Access Compliance Report

Public Rights-of-Way (Curb Ramps)

Intersection ID: 30087	Main Street: DEVONBRIDGE_LN	Cross Street: DEVONHILL_LN	Location: NW
ADA ID: C7F2B1BE6FB5	Ramp Type: PerpDiag	Initial Pass/Fail: Pass	Overall Compliance: No Severity Score: 15.25

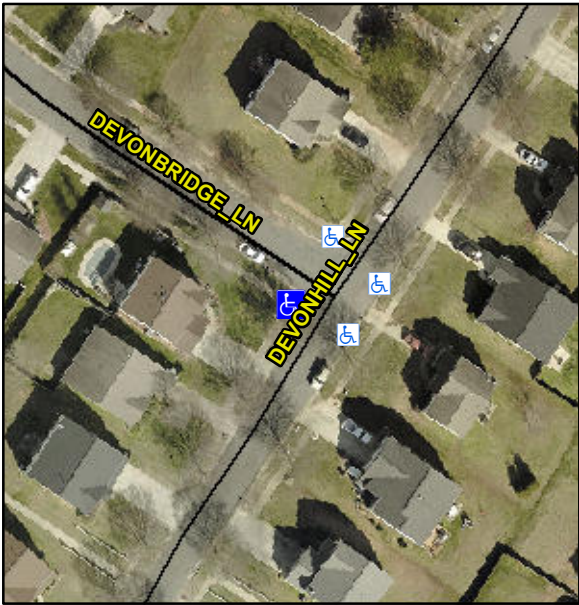
Codes/Mitigation Info/Possible Solution			Field Measurements/Component Compliance					
	Possible Solutions:		Compliance	Description	Data	Compliance	Description	Data
	Remove & Replace Curb Ramp With Two New Directional Ramps or Equivalent. Remove & Replace Gutter.		N/A	Ramp Length (in)	35.0	Yes	Ramp Slope (%)	5.7
			Yes	Ramp Width (in)	48.0	No	Ramp XSlope (%)	4.8
			N/A	Flare Type LT	Sloped	N/A	Flare Type RT	N/A
			N/A	Flare Slope LT (%)	2.5	N/A	Flare Slope RT (%)	10.1
			N/A	Flare Traversable LT?	No	N/A	Flare Traversable RT?	No
	Surveyor Notes:		Yes	Landing Length (in)	88.0	Yes	DWS Provided?	Yes
			Yes	Landing Width (in)	48.0	Yes	DWS Contrast?	Yes
			Yes	Landing Slope (%)	0.8	Yes	DWS Length (in)	24.0
			No	Landing X Slope (%)	7.1	Yes	DWS Full Width?	Yes
N/A			Landing Curb? (Y/N)	No	No	DWS Offset (in)	8.0	
PROW/ADA: Not Found, R304.5.3, R305.2, R302.7, R302.7.2		N/A	Shared Landing?	No				
		No	Gutter Ponding?	Yes	Yes	Gutter Slope (%)	2.2

No	Gutter Lip Ht (in)	1.0	No	Gutter X Slope (%)	3.4	
		N/A	Painted X Walk1?	No	N/A	Painted X Walk2?	No	
			X Walk 1 Direction	To S		X Walk 2 Direction	To E	
		N/A	X Walk 1 Width (in)	N/A	N/A	X Walk 2 Width (in)	N/A	
			X Walk 1 Slope (%)	2.7		X Walk 2 Slope (%)	7.3	
			X Walk 1 X Slope (%)	7.0		X Walk 2 X Slope (%)	0.7	
		N/A	Ramp inside XWalk1?	N/A	N/A	Ramp inside XWalk2?	N/A	
			Road Slope (%)	5.4	N/A	Clear Space?	Yes	
Total Cost: \$ 3950.00			Road X Slope (%)	6.4	N/A	Clear Space to XWalk (in)	N/A	
		Yes	Any Obstructions?	No	Yes	Storm Grate/Utility Hazard?	No	
			Obstruction Type			Storm Grate/Utility Type		
				N/A			N/A	
					Yes	Surface Condition? (G/P)	Good
